**HYUNDAI**
Technical Service Bulletin

GROUP	NUMBER
ENGINE MECHANICAL	25-EM-005H
DATE	MODEL(S)
JUNE 2025	SANTA CRUZ (NXT)

SUBJECT: INTEGRATED THERMAL MANAGEMENT (ITM)
REPLACEMENT & ECU SOFTWARE UPDATE – DTC P218100

This TSB supersedes 23-EM-006H to add the water inlet O-ring and pink coolant to the “Parts Information” section (page 2), add the “SST Information” section (page 2), update ROM ID Information and Manual Mode Passwords (pages 4 & 11), and add a separate “ECU Update Procedure” section (pages 7-11).

ITM Replacement

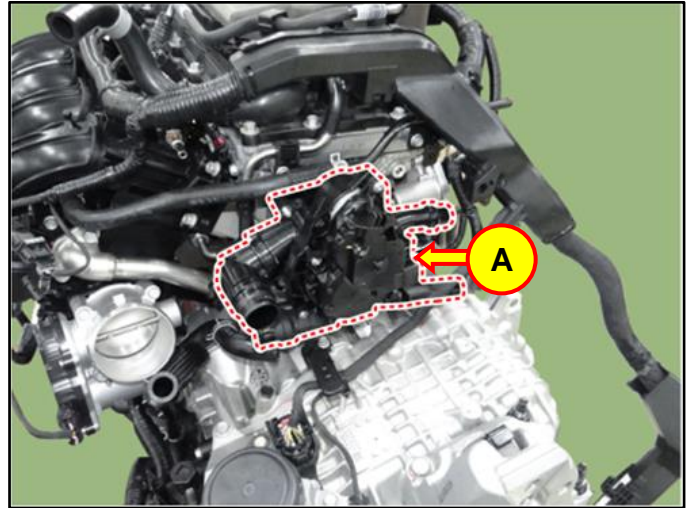
1. Utilize the GDS to detect DTC P218100:
Cooling System Performance:
 - If DTC P218100 is present, then replace the ITM (A) by referring to the shop manual.
 - **Engine Mechanical System > Cooling System > Integrated Thermal Management > Repair procedures**
 - If DTC P218100 is **NOT** present, then the service procedure is now complete.
